Tips & Tricks – All Models

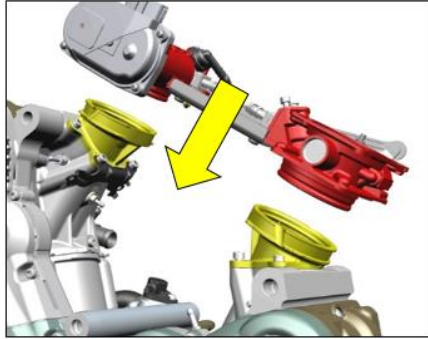
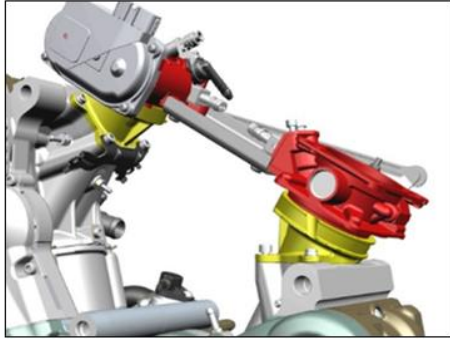
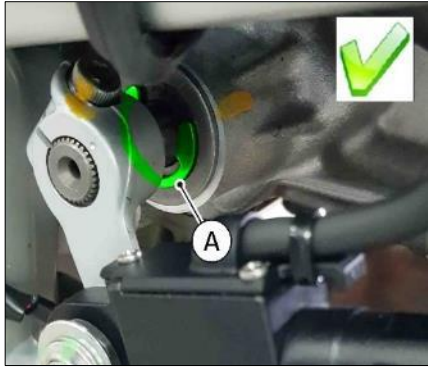
no.	Symptom	Subject	Photo	Notes and Indications - Corrective action
1	<p><u>ONLY</u> <u>Monster 821</u> <u>Monster 1200</u> <u>SuperSport</u></p> <p>Possible engine popping sound during deceleration and/or irregular idling</p>	Airbox		<p>We have received some complaints about a possible engine popping sound during deceleration. The performed analyses have shown that this symptom could be caused by an incorrect installation of the throttle bodies in the relevant intake manifolds (possible deformation of the rubber profile).</p> <p>Therefore, if you find any similar symptoms, we kindly ask you to check the correct installation of the Airbox on the motorcycle and that:</p> <ul style="list-style-type: none"> - throttle bodies are correctly inserted inside rubber intake manifolds, along the whole perimeter; - the rubber profile of the intake manifolds is not deformed. - the 2 fastening ties are correctly positioned in the seat on the intake manifolds. <p>Please be reminded that, to make throttle body insertion easier on rubber intake manifolds, the use of silicone lubricant or similar product is absolutely necessary.</p> <div style="display: flex; justify-content: space-around;">   </div>

2	<p><u>ONLY</u> <u>Panigale V4</u> <u>(all versions)</u> <u>Streetfighter V4</u> <u>(all versions)</u></p> <p>Introduction gear selector shaft certification</p>	Gear selector		<p>We have received some isolated reports of a possible loss/absence of the snap ring (A) of the gear selector shaft. We would like to inform you that an additional certification on all Desmosedici Stradale engines between snap ring, washer, and crankcase at the outlet of the gear selector shaft has been added along the production line. The first engine serial number with this new certification is ZDM1100WC #001513#.</p> <p>Upon the first workshop service, you are thus invited to check for the presence of the snap ring (A) on all engine serial numbers preceding the one specified above.</p>

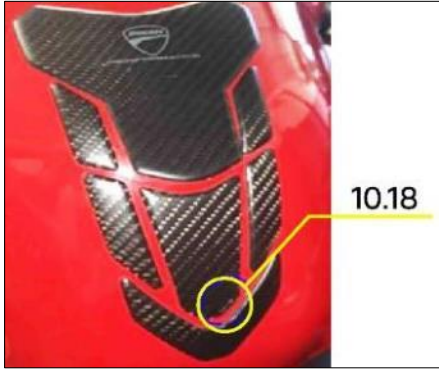
no.	Symptom	Subject	Photo	Notes and Indications - Corrective action
7	<p><u>ONLY</u> <u>models equipped with</u> <u>hydraulically controlled</u> <u>clutch lever</u></p> <p>Possible reduction of the clutch fluid level inside its reservoir</p>	Hydraulic clutch control		<p>We received a few claims concerning a reduction of the clutch fluid level inside its reservoir. We would like to inform you that it is not sufficient to carry out the bleeding procedure or top up the clutch fluid inside the reservoir. We suggest, at a preliminary stage, to check:</p> <ul style="list-style-type: none">• the play between the clutch master cylinder and the lever• if the clutch pushrod is worn or damaged in the area of contact with the clutch slave cylinder (ball)• the condition of the clutch slave cylinder protective diaphragm, which must not be torn. <p>According to our analyses, this phenomenon is due to a DOT4 leakage from the primary seal of the clutch slave cylinder (missing fluid in the reservoir builds up in-between the clutch slave cylinder diaphragms); in some cases, this phenomenon is also accompanied by wear of the clutch pushrod. We therefore ask you to replace the slave cylinder with a new part no. 19540091D featuring a new gasket in order to prevent the phenomenon described above.</p> <p>If the clutch pushrod is damaged as shown in the figure, replace it as well.</p> <div data-bbox="1256 727 1995 1003"></div>

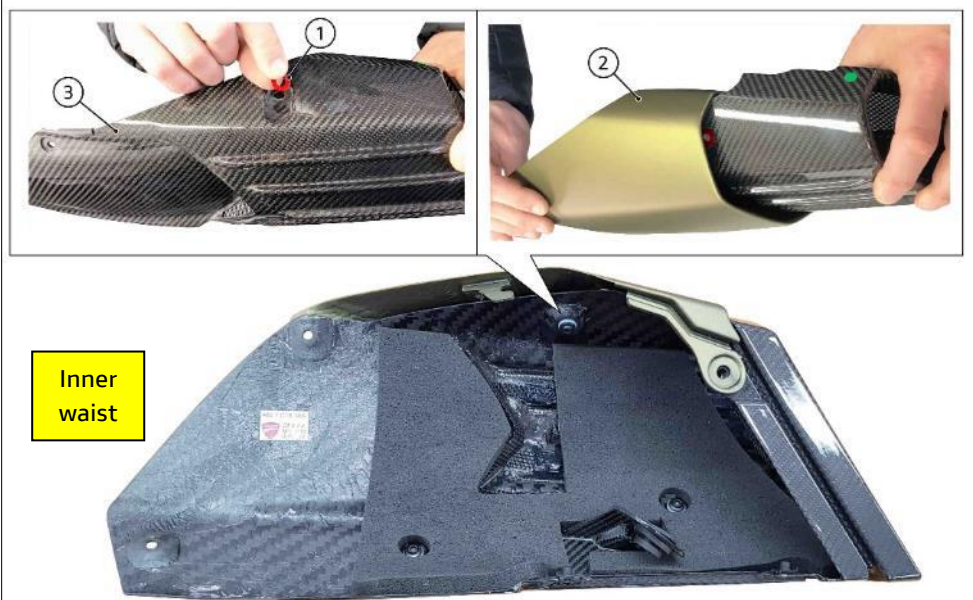
no.	Symptom	Subject	Photo	Notes and Indications - Corrective action																					
13	<p><u>ONLY</u> Streetfighter V4 Panigale V4 Superleggera V4</p> <p>Instrument panel failed switching on upon Key-ON</p>	Instrument panel	-	<p>We received some isolated reports about instrument panel failed switching on; this phenomenon is due to a damage of the instrument panel power supply circuit caused by power disturbance. Should this phenomenon persist, the component must be replaced. The spare instrument panels have been restored thanks to the introduction of a new circuit avoiding the described symptom.</p>

Model	Model Year	Part no.	Streetfighter V4	20	40611781C	Panigale V4 25° Anniversario 916	20	40611351I	Panigale V4	18-19	Panigale V4 S	Panigale V4 S Corse	20	40611351H	Panigale V4	Panigale V4 S	Panigale V4 S Corse	Superleggera V4		
Model	Model Year	Part no.																							
Streetfighter V4	20	40611781C																							
Panigale V4 25° Anniversario 916	20	40611351I																							
Panigale V4	18-19																								
Panigale V4 S																									
Panigale V4 S Corse	20	40611351H																							
Panigale V4																									
Panigale V4 S																									
Panigale V4 S Corse																									
Superleggera V4																									
14	<p><u>ONLY</u> Diavel Model Year 21 XDiavel Model Year 21 Multistrada 1260 Model Year 18-20 Multistrada 1260 Enduro Model Year 19-21 Multistrada 950S Model Year 19-21</p> <p>Possible loss of the active key rear cover</p>	Active key Part no. 59810361F		<p>We have received some isolated reports about the possible loss of the rear cover of the active key Part no. 59810361F. Analyses have shown that this phenomenon occurs after repeated opening/closing of the cover itself, resulting in the deterioration of the shell.</p> <p>We would like to inform you that the new rear cover Part no. 4601L831A, avoiding the phenomenon described above, is now available.</p>

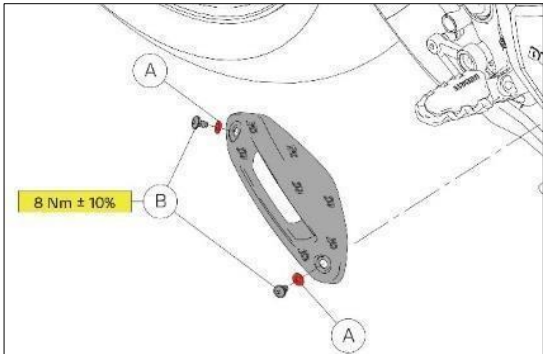
no.	Symptom	Subject	Photo	Notes and Indications - Corrective action
14	<p><u>ONLY</u> <u>Panigale V4 S</u> <u>Streetfighter V4 S</u></p> <p>Possible storage of errors:</p> <ul style="list-style-type: none">- C100C shock absorber rebound - Open circuit- C1009 shock absorber compression - Open circuit	Öhlins monoshock	-	<p>We have received some reports of the following errors being stored:</p> <ul style="list-style-type: none">- C100C: shock absorber rebound - Open circuit;- C1009: shock absorber compression - Open circuit. <p>If any of the above errors are detected, please carry out the following test to confirm the need for replacement of the Öhlins rear monoshock:</p> <ol style="list-style-type: none">1) Swap the connections of the compression and rebound stepper motors;2) Delete any errors stored;3) Perform a Global Scan and determine if a new error code for the rear shock damping is validated4) If it is so, change the rear monoshock.

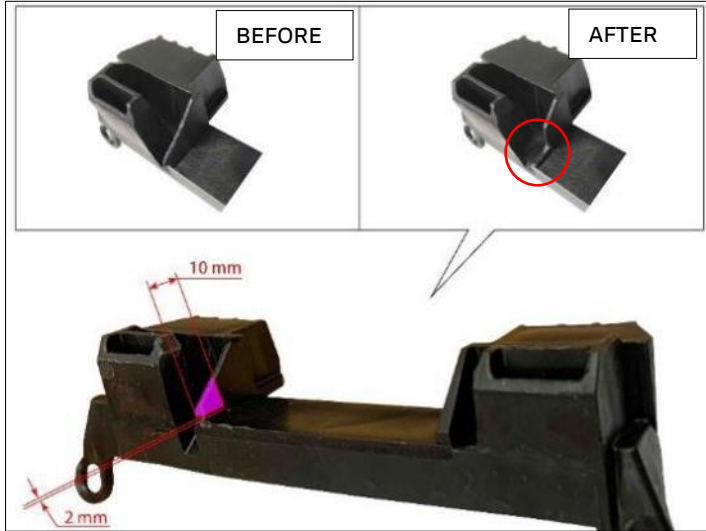
no.	Symptom	Subject	Photo	Notes and Indications - Corrective action
<p>NEW</p> <p>3</p>	<p>ONLY Hypermotard 950 MY22</p> <p>Possible validation of errors P2A03 Horizontal cylinder lambda sensor (oxygen sensor) [Value out of range] and/or P2A00 Vertical cylinder lambda sensor (oxygen sensor) [Value out of range]</p>	<p>Lambda sensors</p>	<p>-</p>	<p>We have received some isolated reports of the possible validation of the following errors:</p> <ul style="list-style-type: none"> • P2A03 Horizontal cylinder lambda sensor (oxygen sensor) [Value out of range] • P2A00 Vertical cylinder lambda sensor (oxygen sensor) [Value out of range] <p>after riding only 1000km/600mi.</p> <p>Our analysis has shown that this phenomenon is linked to the possible installation of lambda sensors relating to the previous Model Year (Model Year 2020-2021 EURO4 version) despite having the same connector on the wiring side.</p> <p>We would like to inform you that the production line has made the process more robust in order to avoid this issue.</p> <p>Should you find the above mentioned errors, we ask you to ensure that the dedicated lambda sensors part no.55215021A for the Hypermotard 950 Model Year 2022 are actually installed.</p> <div style="display: flex; justify-content: space-around; align-items: center;"> <div style="text-align: center;">  <p>Hypermotard 950 Model Year 2020-2021</p>  </div> <div style="text-align: center;">  <p>Hypermotard 950 Model Year 2022</p>  </div> </div>

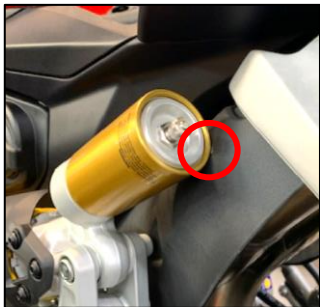
no.	Symptom	Subject	Photo	Notes and Indications - Corrective action
11	<p style="text-align: center;"><u>ONLY</u> 959 Panigale (all versions)</p> <p>Possible hardening of gear shift control with difficulty in shifting gears when hot</p>	Gear selector	-	<p>We have received some isolated reports about a possible hardening of the gear shift when hot with consequent difficult selection of gear ratios. Based on the analyses carried out, this phenomenon could be due to a hardening between the gearbox sensor magnet plastic support and the relevant seat inside the cover.</p> <p>You are kindly asked to carry out the following operations:</p> <ol style="list-style-type: none"> 1) Remove the gear shift cover (1) on motorcycle LH side; 2) Check for the presence of shim (2); 3) Mill the end face of the plastic cage for the selector magnet (3) shorter by 0.1 mm maximum and the outer curved edge where it enters the bore of the cover by 0.1 mm maximum, <u>or</u> mill the internal surface (4) of the cover highlighted in the figure and remove 0.1 mm maximum of material from the end and bore of the recess. Ensure the orientation of the magnet is not changed on the shift selector or the gear position will not be able to be determined by the sensor. <div style="display: flex; justify-content: space-around; margin-top: 10px;">    </div>

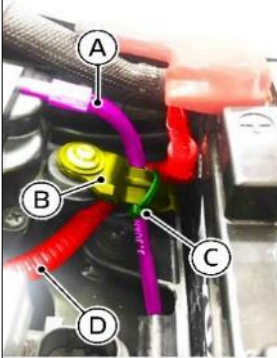
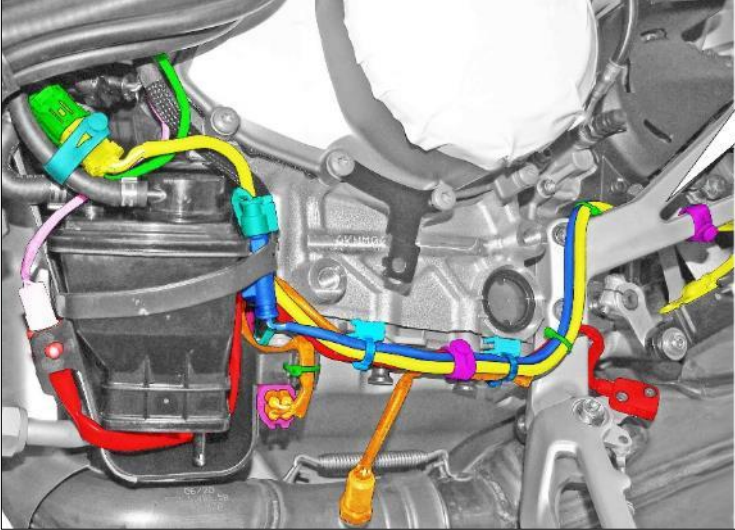
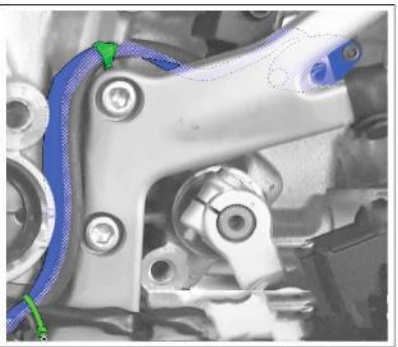
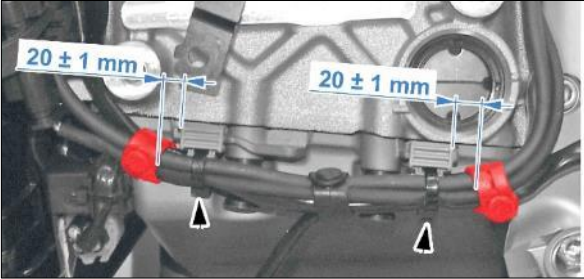
no.	Symptom	Subject	Photo	Notes and Indications - Corrective action				
1	<p><u>ONLY Scrambler 800 (all model versions and MY, excluding Desert Sled model version)</u></p> <p>Precautions when routing the rear brake caliper hose</p>	Rear brake hose	-	<p>We have found that sometimes, during maintenance operations, the rear brake caliper hose is not correctly positioned along the frame due to incorrect installation by the technician during service.</p> <p>Make sure that the rear brake caliper hose (yellow), passes outside the left side cover mounting bracket with respect to the motorcycle centerline and is fixed with the two self-locking ties (red) as shown in the figure.</p> <p>The operation of inspection and possible repositioning is very simple and involves the disassembly of the left side cover only.</p> 				
2	<p><u>ONLY Scrambler 1100 (all model versions)</u></p> <p>Assembly precautions for Bracket accessory kit for side panniers part no. 96781361A</p>	Bracket accessory kit for side panniers part no. 96781361A		<p>Due to a supply error, you may find brackets for soft side bags inside the accessory kit and the presence of a pair of non-compliant M10X45 screws as they are partially threaded instead of completely threaded, as shown in the figure.</p> <p>We ask you to always check that all the kit components are present and correct before installing them and, if the screws are not correct, order the 2 screws M10X45 part no. 77242713C (the parts in stock have been reclaimed).</p> <table border="1" data-bbox="1167 895 2051 1098"> <thead> <tr> <th data-bbox="1167 895 1608 935">NON-COMPLIANT Screw M10X45</th> <th data-bbox="1608 895 2051 935">COMPLIANT Screw M10X45</th> </tr> </thead> <tbody> <tr> <td data-bbox="1167 935 1608 1098">  </td> <td data-bbox="1608 935 2051 1098">  </td> </tr> </tbody> </table> <p>We would also like to inform you that there is a label on the kit box, and at the top right it bears numbers indicating the progressive number and the year of manufacture. The kits that may include the 2 non-compliant M10X45 screws and therefore need to be inspected before proceeding with the installation are numbers "19053" and "19064".</p> 	NON-COMPLIANT Screw M10X45	COMPLIANT Screw M10X45		
NON-COMPLIANT Screw M10X45	COMPLIANT Screw M10X45

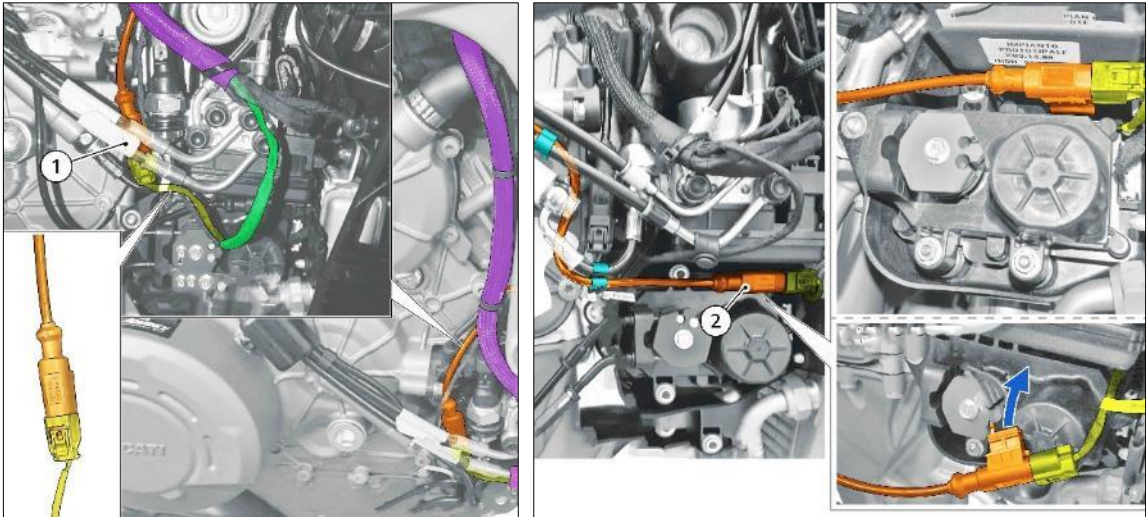
no.	Symptom	Subject	Photo	Notes and Indications - Corrective action
3	<p><u>ONLY</u> <u>Scrambler Desert Sled</u> <u>Scrambler ICON</u> <u>Scrambler Full Throttle</u> <u>Model Year 2019 - 2020</u></p> <p>Possible brake fluid leaks from reservoir cover</p>	Front brake fluid reservoir		<p>We inform you that in case of complaints from Customers about a possible oozing out of front brake fluid from the relevant reservoir, This condition does not affect the operation of the brake system. it is possible to order the following kit part no. 89340331A as spare part to avoid the symptom in question.</p> <p>The kit part no. 89340331A includes:</p> <ul style="list-style-type: none"> • 2 screws (1) • Cover (2) • Membrane (3) • Baffle (3) 
4	<p><u>ONLY</u> <u>Scrambler 1100</u> <u>Model Year 2020</u> <u>(all model versions)</u></p> <p>Precautions during PDI: installation of the battery on the vehicle</p>	Battery assembly	-	<p>During the installation of the battery on the vehicle and, in any case, when the motorcycle first comes to the workshop for a service, we ask you to always check the correct positioning of the exhaust butterfly valve cable (A) under the retainer (B) and the presence of the self-locking tie (C).</p> <p>Make sure the motorcycle positive cable (D) is positioned under the exhaust butterfly valve cable (A).</p>

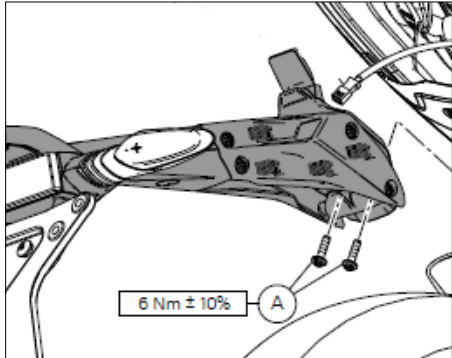
no.	Symptom	Subject	Photo	Notes and Indications - Corrective action
4	Assembly precautions Anti-theft system kit part no. 96680811A	Anti-theft system kit Part no. 96680811A		Please, be reminded that if anti-theft system kit Part no. 96680811A is installed for model Streetfighter V4, the anti-theft system/DMS support set (additional wiring with anti-theft system fastening support bracket) Part no. 96680941BA must be purchased at the same time, as specified on the spare part catalogue "compatibility" section.
5	Possible flashing of low fuel light	Low fuel warning light	-	<p>We have received some isolated claims about the flashing of low fuel light; this phenomenon is due to an electric problem of the thermistor resulting in the validation of Error P0460 - Fuel level sensor [Short circuit to positive or Open circuit].</p> <p>Please, fill in a Youtech service request and then replace the component by ordering a new spare one Part no.69928751A.</p>

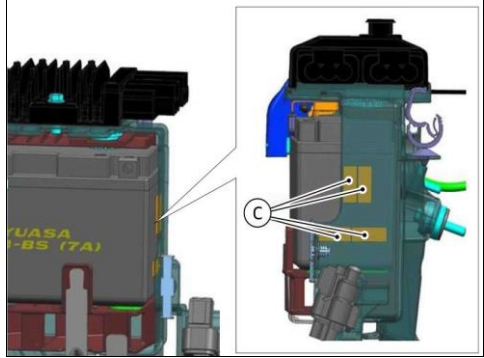
no.	Symptom	Subject	Photo	Notes and Indications - Corrective action
9	<p><u>ONLY</u> Streetfighter V4 MY21 (all versions)</p> <p>New brake master cylinder and clutch master cylinder</p>	Brake master cylinder and Clutch master cylinder	-	<p>All Streetfighter V4 Model Year 2021 versions are equipped with the new "self-purging" front brake master cylinder and clutch master cylinder (the previous Model Year featured the "traditional" front brake master cylinder and clutch master cylinder).</p> <p>At first sight, they may appear visibly similar to those installed on the Multistrada V4 model (presence of the hole for hand guards fitting) but they are not the same and cannot be interchanged, as the distance between centers of the lever as well as the shape of the lever itself are different.</p>
